Addendum (ADD) #01

| Project: | 20-602: Marshfield Early Childhood Center |
| Client: | Marshfield R-I School District |
| Date: | June 15, 2021 |

PROJECT DESCRIPTION:
C201 MARSHFIELD ECC OVERALL SITE PLAN - PHASE ONE

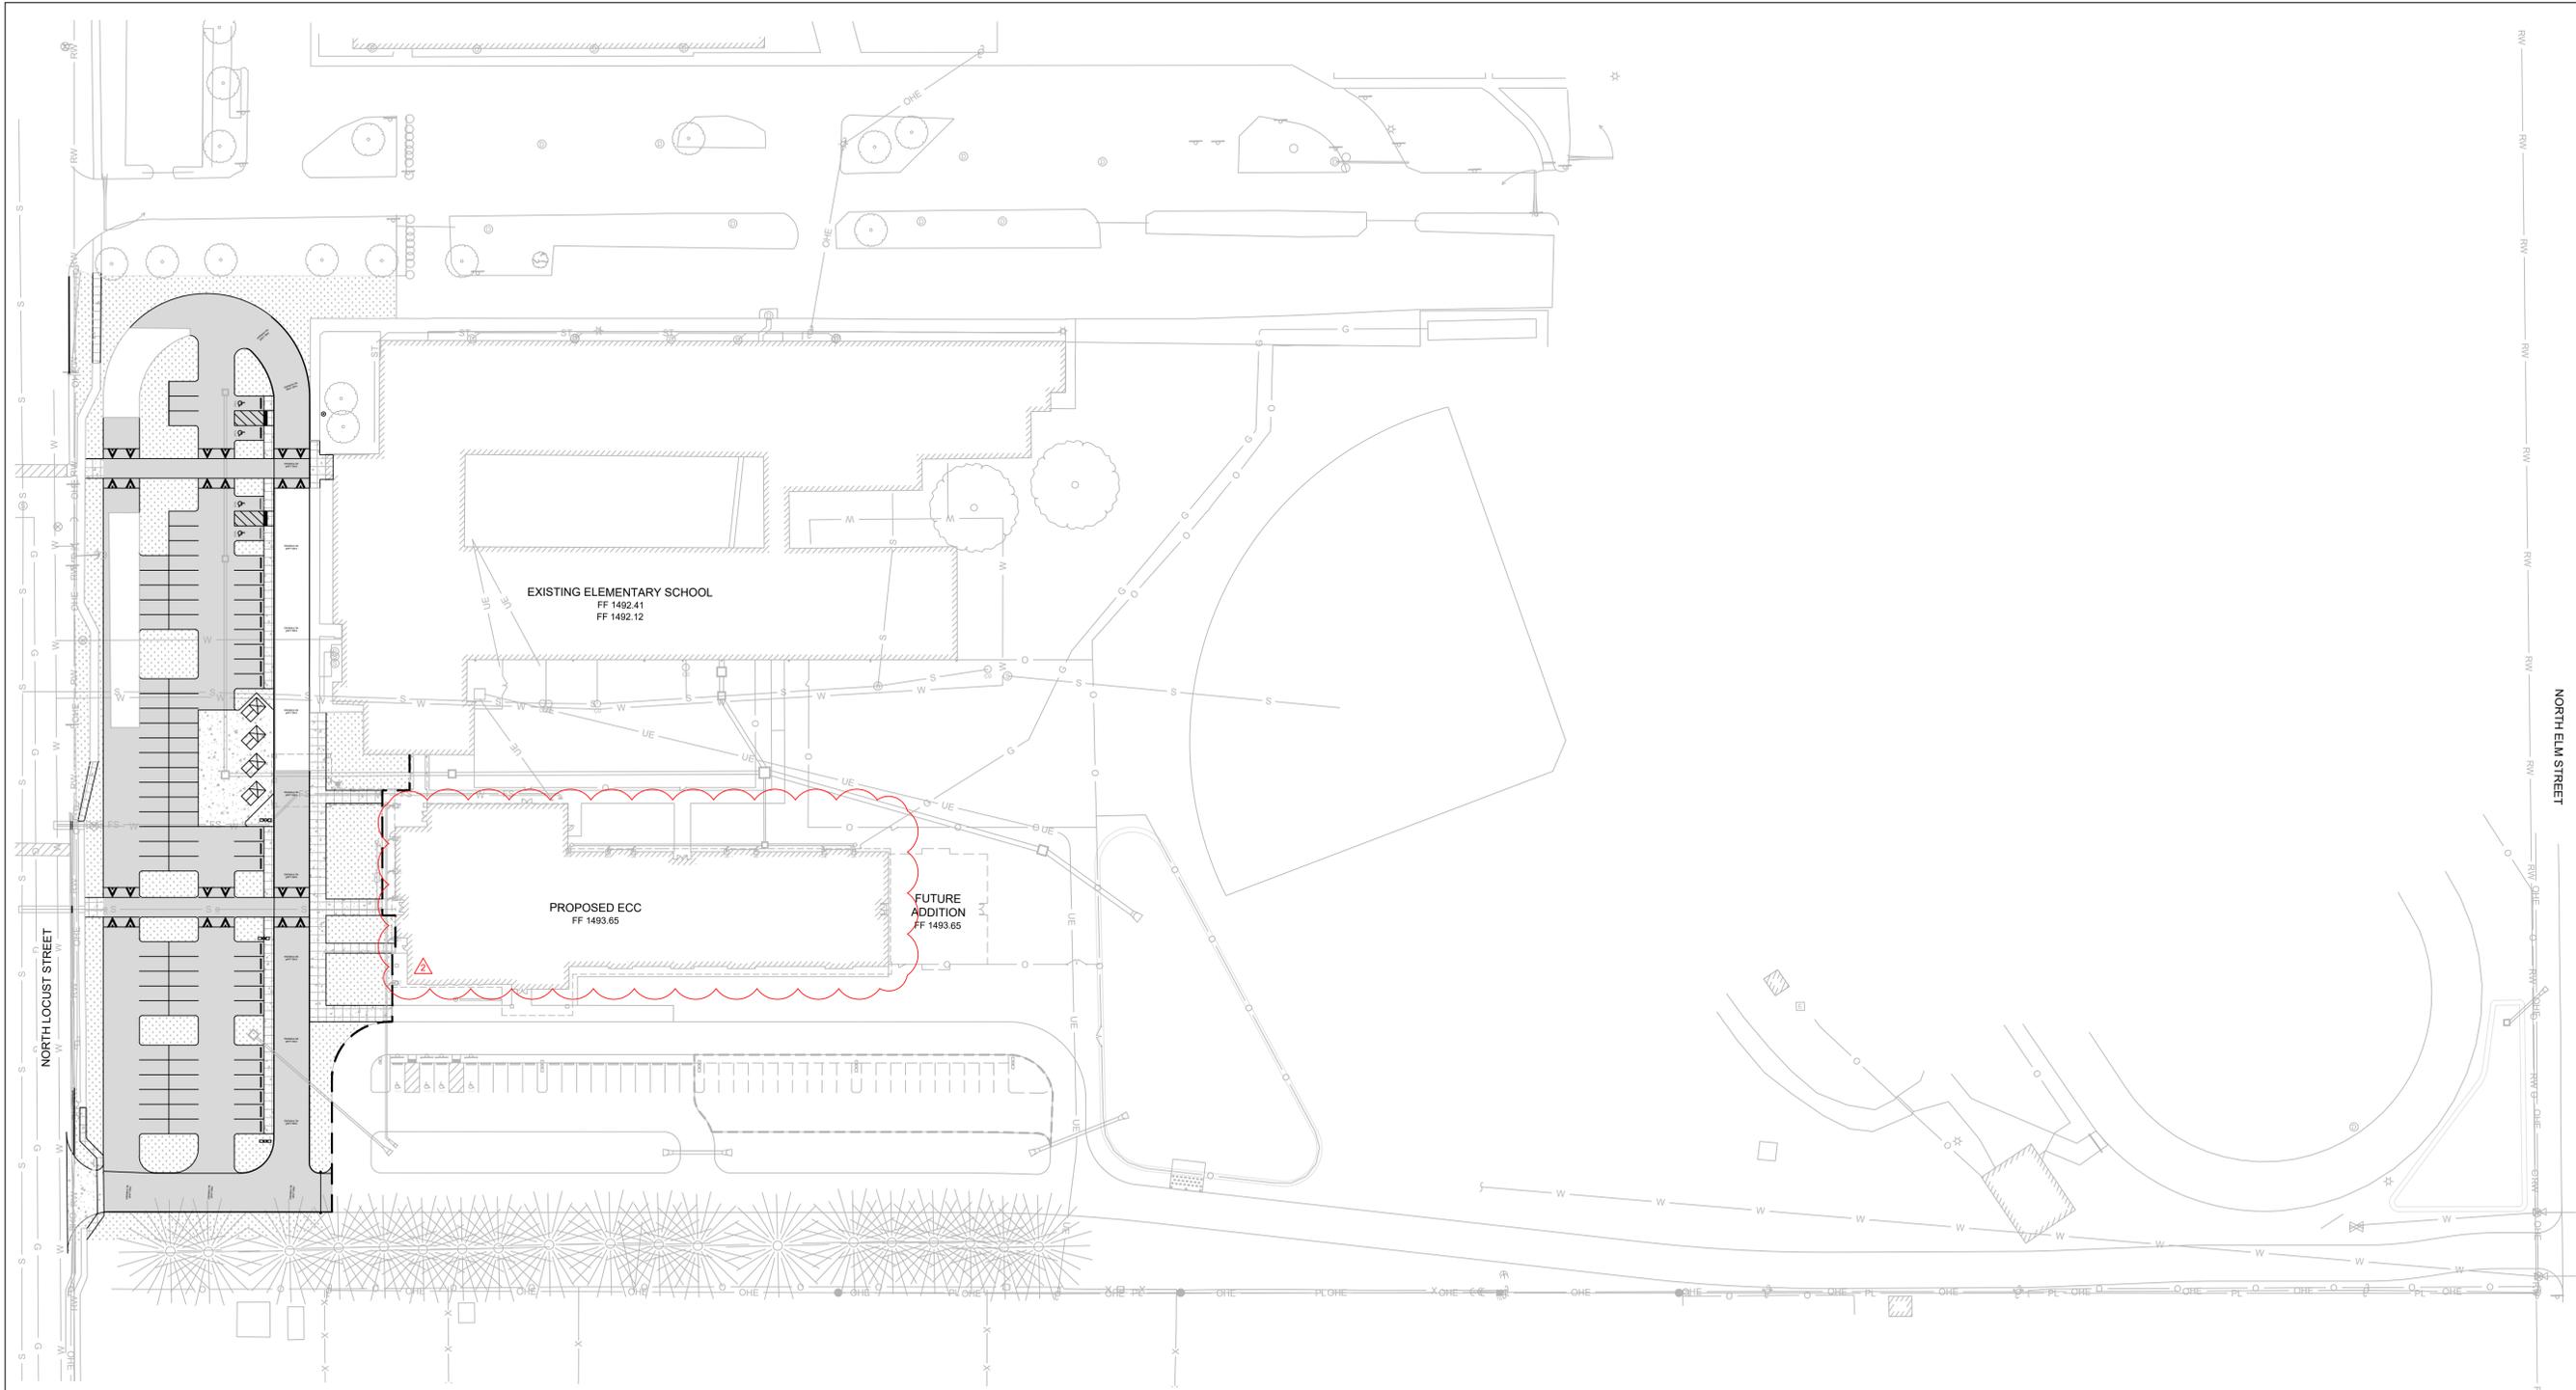
1. Sheet C201, C202, C204, C301, C303, and C401 have been updated to accommodate the revised building footprint.

PROJECT NUMBER: **S1-2 MARSHFIELD ECC FOUNDATION PLAN-AREA B**
 PROJECT NUMBER: **20-602**
 DATE: 06/09/2021
 PROJECT DESCRIPTION: 600 N. Locust St., Marshfield, MO 65706
 PROJECT ENGINEER: CHARLES M. TAYLOR
 DRAWN BY: FEM
 CHECKED BY: CMT
 BIM 360://Marshfield ECC #20-602/SS-STRU-ECC_R19_CLOUD.rvt

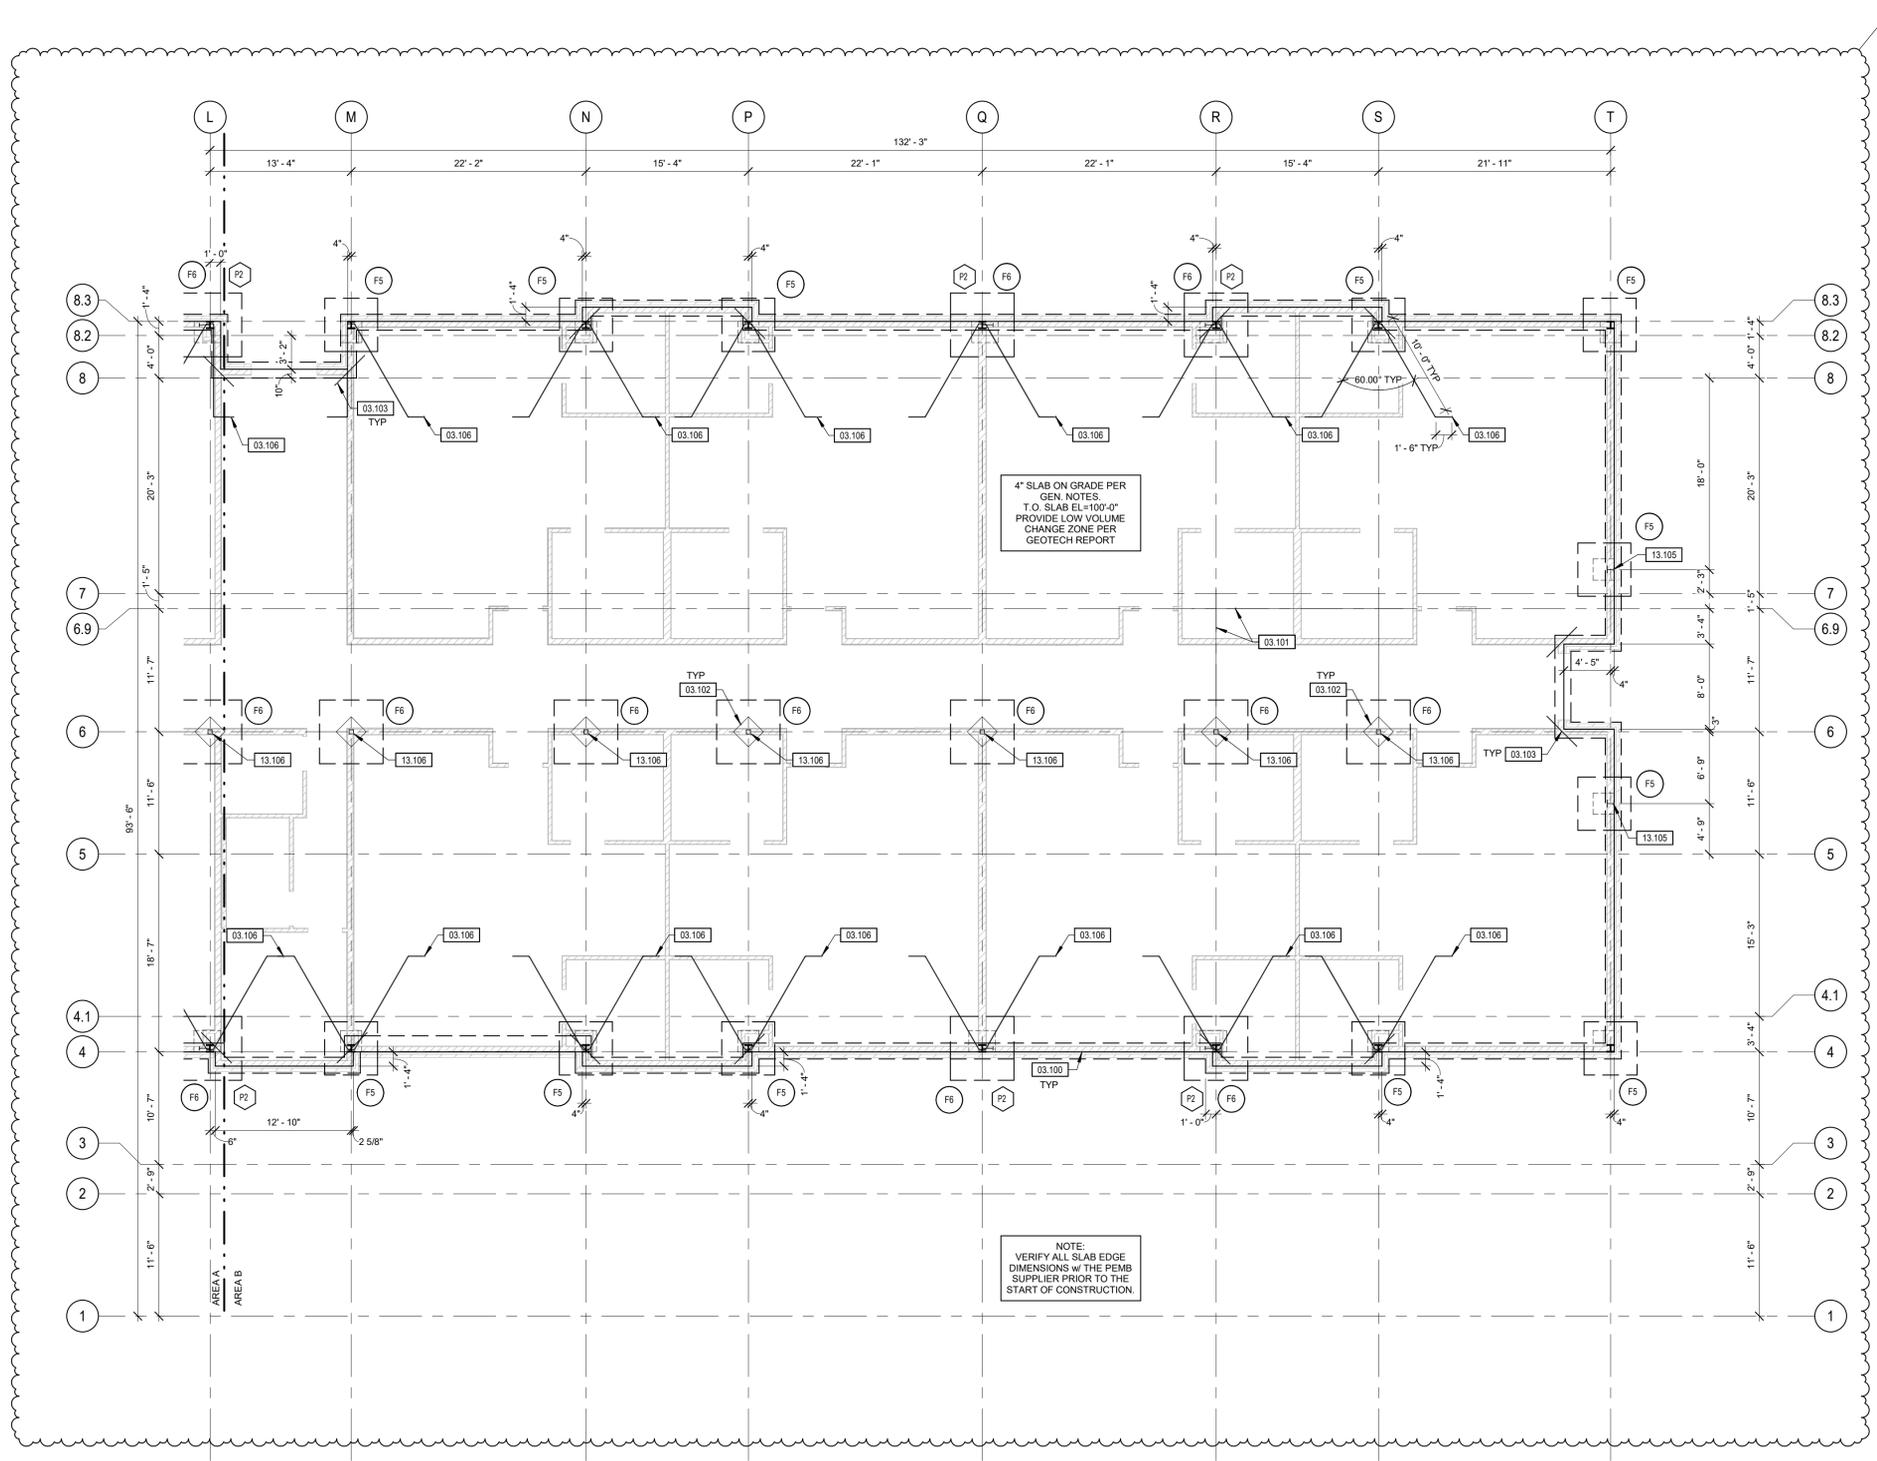
- S1-1
 - Revised classroom wing slab edge dimensions & column layout to coordinate with latest PEMB supplier plans.
- S1-2
 - Revised classroom wing slab edge dimensions & column layout to coordinate with latest PEMB supplier plans.
- S2-1
 - Revised Detail 9 to graphically show the PEMB column aligned with the slab edge to coordinate with the plans.
- S3-1
 - Revised PEMB overhang dimensions to coordinate the latest PEMB supplier plans.
 - Revised classroom wing size & column layout to coordinate with latest PEMB supplier plans.
- S3-2
 - Revised PEMB overhang dimensions to coordinate the latest PEMB supplier plans.
 - Revised classroom wing size & column layout to coordinate with latest PEMB supplier plans.

PROJECT DESCRIPTION:
A1-0 MARSHFIELD EARLY CHILDHOOD CENTER
FLOOR PLAN - AREA A

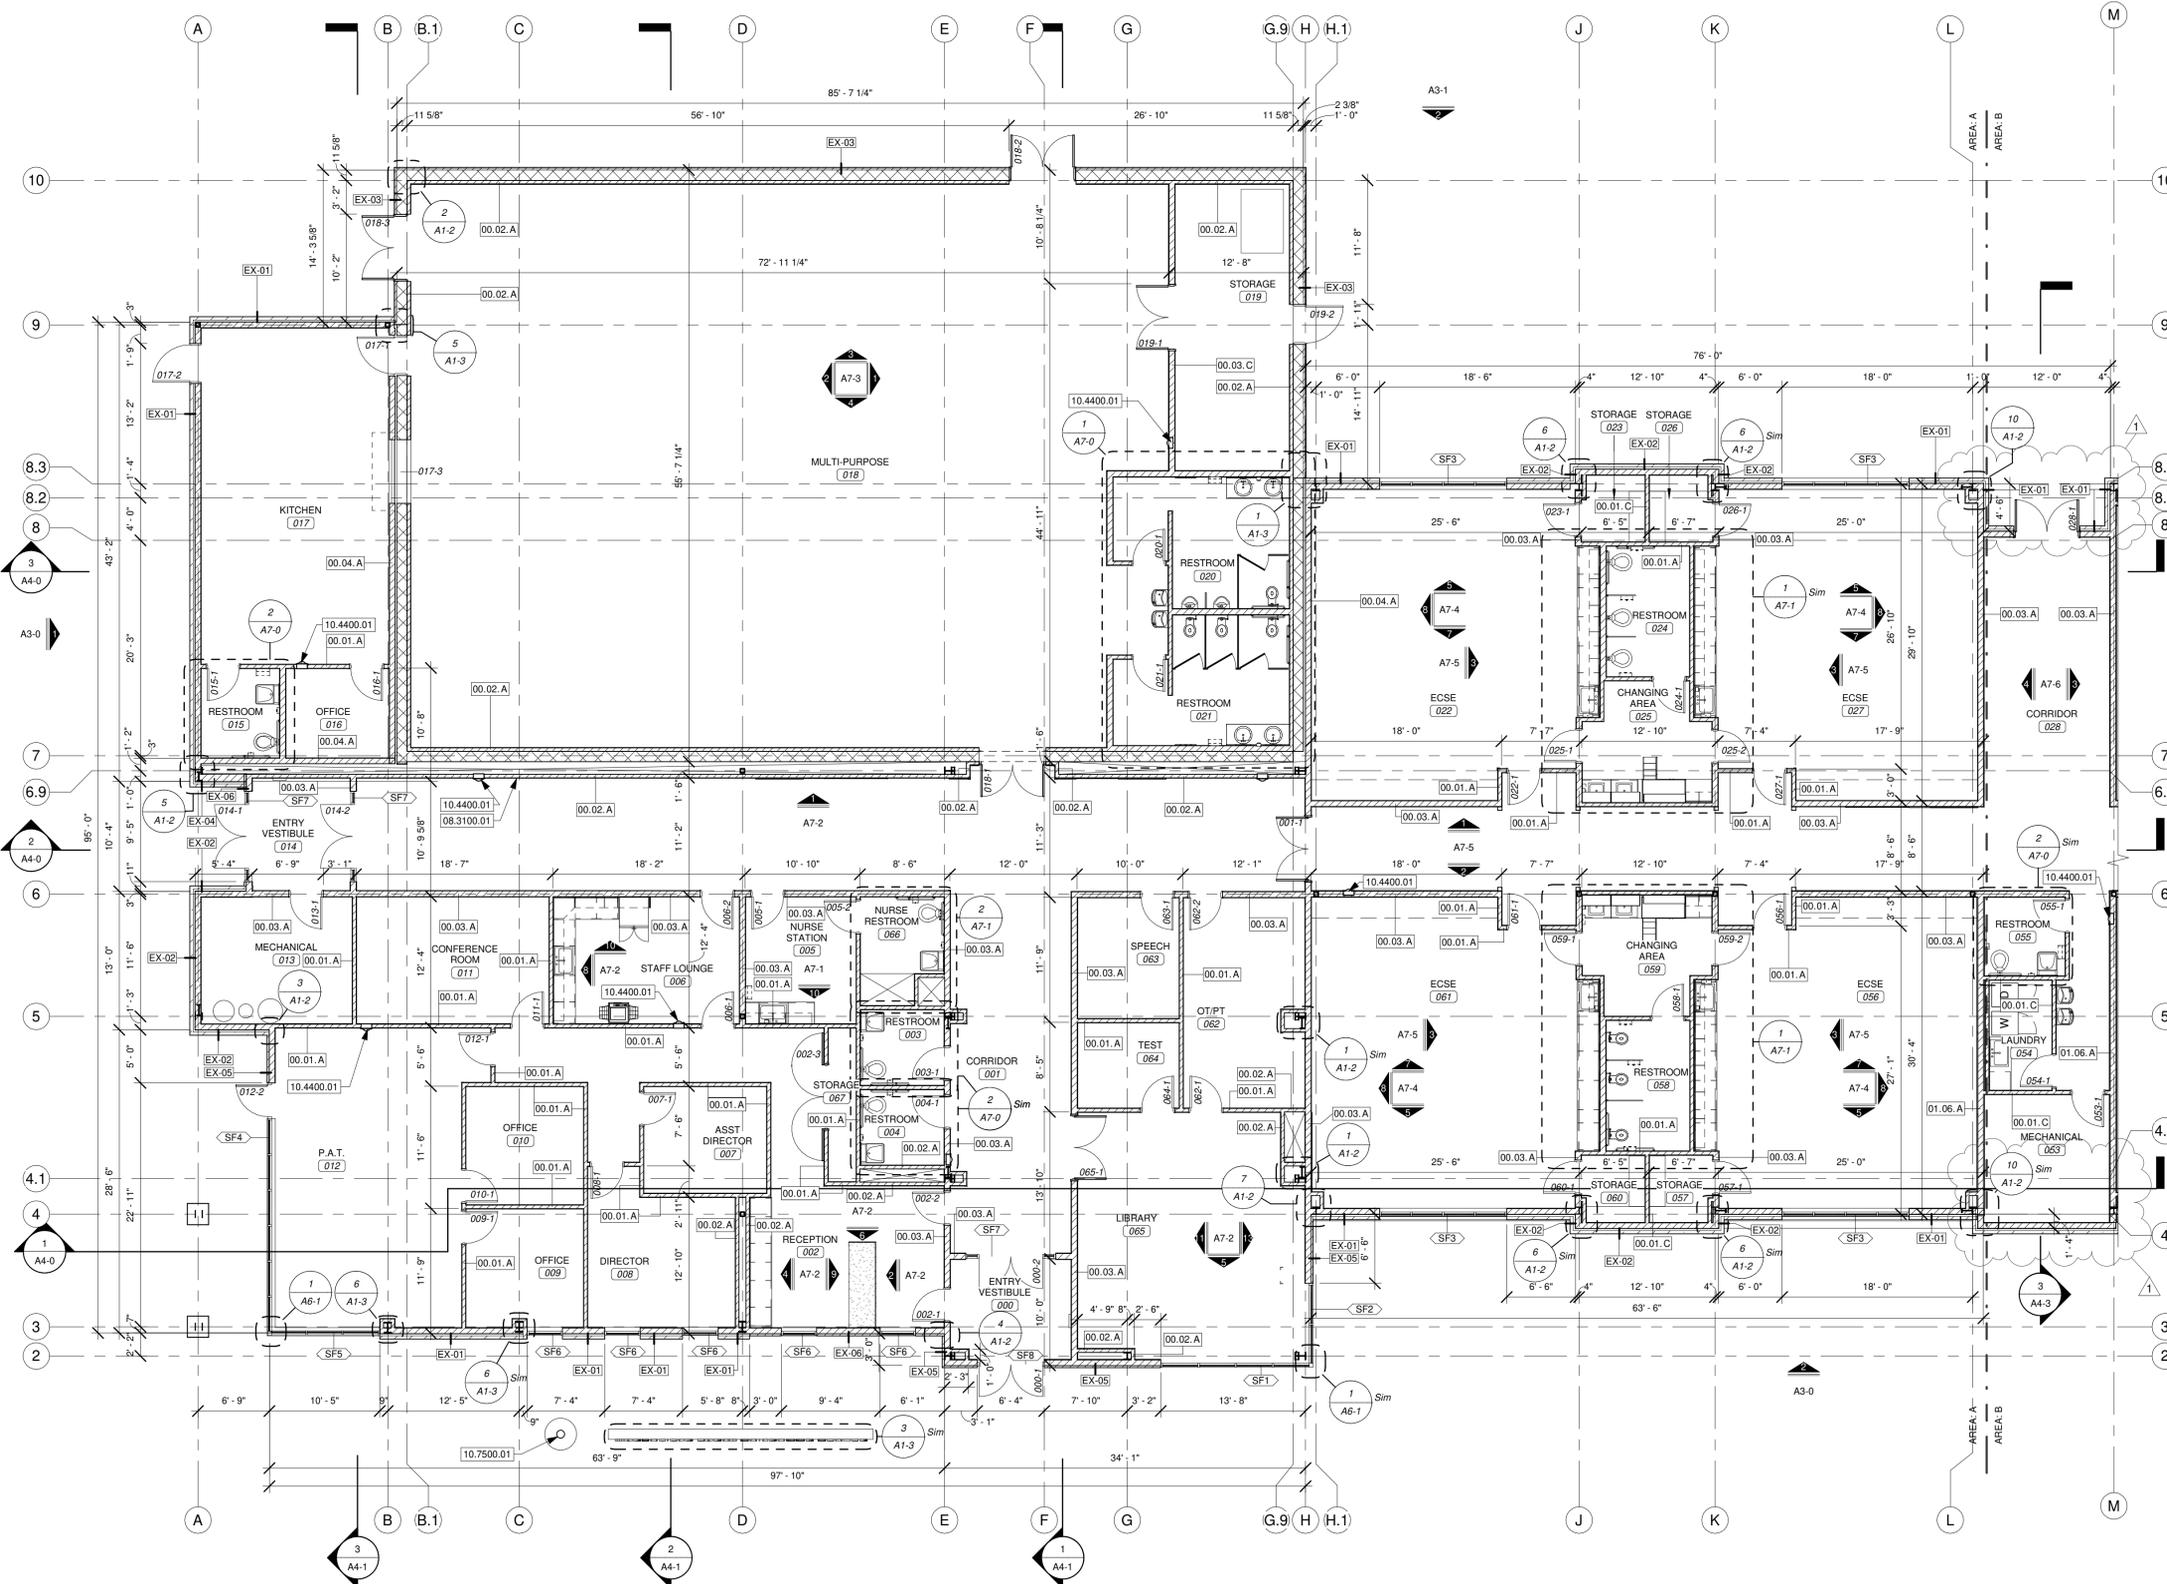
- i. Building footprint adjustments at Corridor 028 and Mechanical 053.
4. *Sheet A1-1 – Floor Plan – Area B:*
 - a. Revise, Detail 1
 - i. Building footprint adjustments at north exterior walls and south exterior walls.
